**Schedule 5 Response - Substantial Variation  
Celsa Manufacturing (UK) Ltd,  
Tremorfa New Melt Shop. Tremorfa Works,  
Seawall Road, Cardiff, CF24 5TH  
Permit Ref: **EPR/TP3639BH****

**Schedule 5 Response (Substantial Variation)**

This report relates to Schedule 5 (II). All attachments have been provided as electronic files only as per the original application. Questions and requests for further information from Schedule 5 (II) are outlined within the blue boxes.

**Figure 2-1: Proposed groundwater monitoring wells**

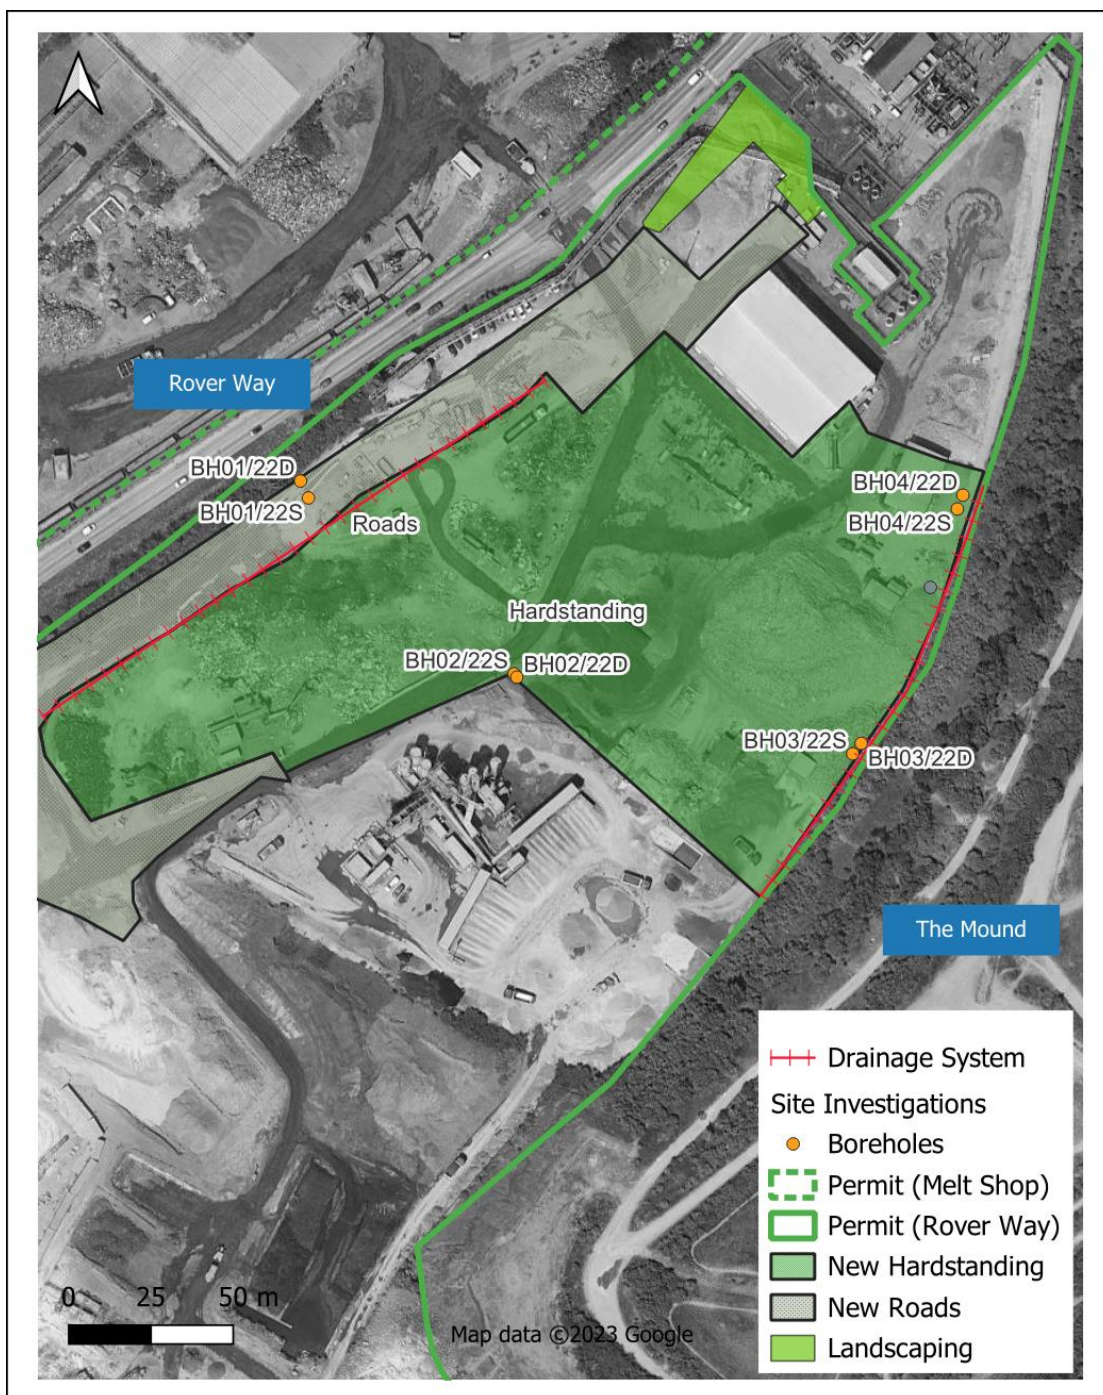
NRW Request – We would expect as a minimum monitoring be installed (see BAT 7 of the waste treatment BRef), such as monitoring wells both up-gradient and down-gradient of the filter strips to determine both the groundwater baseline quality and the quality of the groundwater after the filter strips have been able to filter out contaminants. The monitoring should reveal no net change from background water quality, up- gradient compared to down-gradient monitoring. Submit details of proposed groundwater monitoring or provide a more detailed explanation and justification as to why it is not possible to monitor groundwater discharge from the soakaways.

However, Celsa can now provide some new (post permit submission) borehole data and groundwater monitoring (specific to the shredder area). Celsa would propose to utilise these six new monitoring wells (shallow and deep pairs) as part of the installation monitoring programme (**Figure 2-1**) *i.e.*

- BH01/22D (321427E - 176353N) and BH01/22S (321428E - 176352N)
- BH02/22D (321500E - 176299N) and BH02/22S (321499E - 176300N)
- BH03/22D (321595E - 176279N) and BH03/22S (321594E - 176278N)

BH04/22D (321624E - 176354N) and BH04/22S (321624E - 176353N) has been decommissioned due to the construction works in that area.

BH04 will not be available for monitoring purposes. It is shown on **Figure 2-1** as this is new information not previously provided to NRW.

**Figure 3-2: Surface water run-off sample collection**

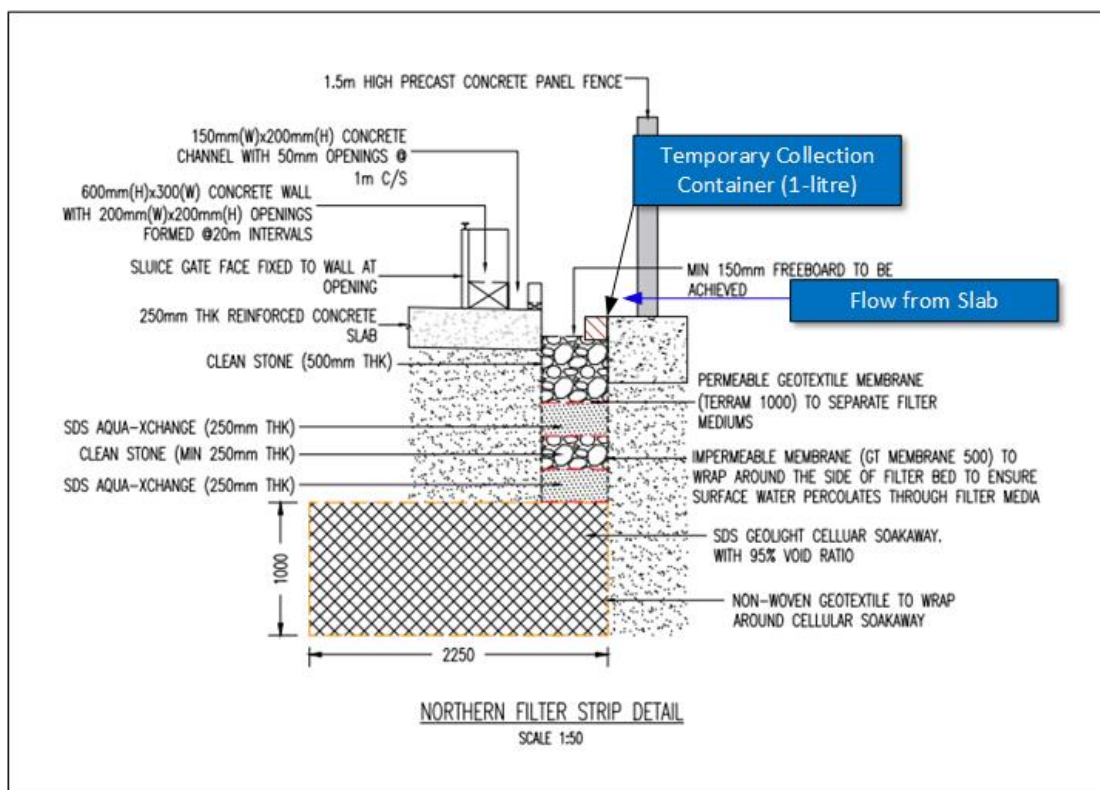
NRW Request – BAT 7 - Provide more details on how you will achieve this BAT and monitor for emissions to water. In the BAT statement you have said that you will meet this BAT but in the not duly made response it was stated that monitoring would not be done.

Given the length of the filter strips it is therefore suggested that periodic composite sampling is undertaken when surface water is flowing from the engineered hardstanding into the infiltration treatment systems. Each of the infiltration treatment systems is to be installed with a minimum 150 mm freeboard between the engineered slab and the filter strip. This should allow the temporary placement of a suitable collection vessel (**Figure 3-2**).

Celsa appreciates that the sample collection method is unusual and falls slightly outside the standard guidance<sup>2</sup> but it would allow the operator to demonstrate the water quality entering the filter strip treatment system.

Celsa would propose that one sample point is installed (agreed with NRW) in each of the filter strips (3 in total). The sample points would be agreed post completion of the filter strips.
